Access Compliance Report

Public Rights-of-Way

(Pedestrian Signals)

Intersection ID: N/A	Main Street:	Cross Street: N/A	Location: N/A
ADA ID: 3EB0A941EE48	Signal Type: One Push Button-APS	Overall Compliance: No	Severity Score: BTN 1: N/A BTN 2: N/A No BTN: N/A
Codes/Mitigation Info/Possible Solution		Field Measurements/Component Compliance

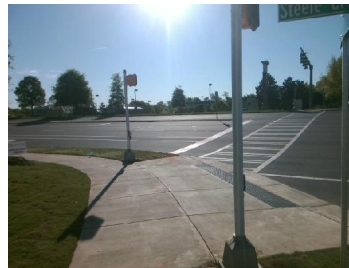
PROW/ADA: TMUTCD 4e.08, R404.2, R404.3, R406.2, R209.1, MUTCD 4e.10

Yes B 1 Clear Xing Direction?	ClearlyMarked	N/A B 2 Clear Xing Direction?	N/A
B 1 Crossing Direction	To SW	B 2 Crossing Direction	N/A
No B 1 DistanceTo XWalk (in)	91.0	N/A B 2 DistanceTo XWalk (in)	N/A
No B 1 DistanceTo Curb (in)	93.0	N/A B 2 DistanceTo Curb (in)	N/A
Yes B 1 Diameter (in)	2.0	N/A B 2 Diameter (in)	N/A

Possible Solutions: Replace Signal Push Button With APS Button on New Post. Remove & Relocate Sign.
